**Inspection Photos**  
**Location Name: Martinez #1A**  
**API: 05-007-06256**

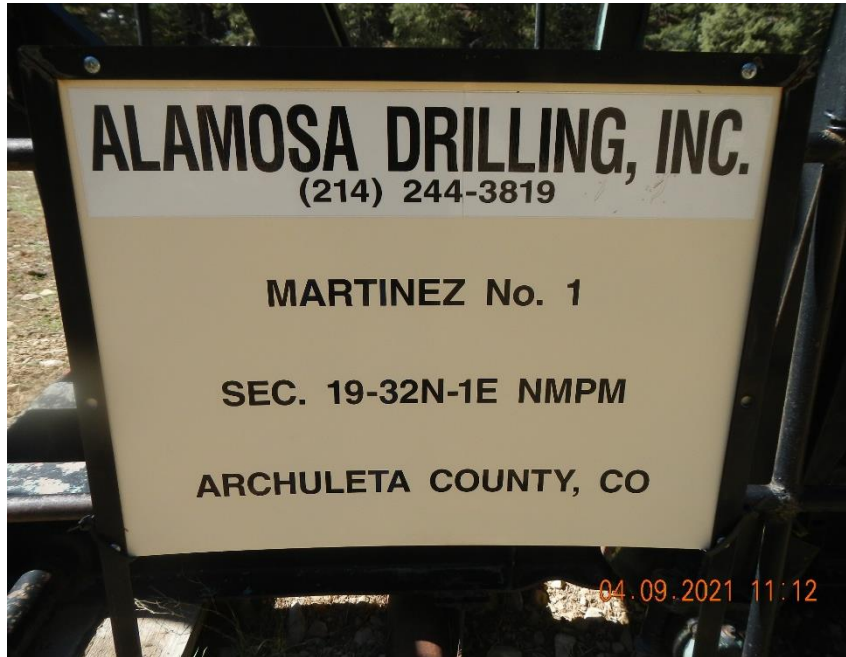
**Martinez #1A well sign near pump jack. Well name is incorrect on location sign.**
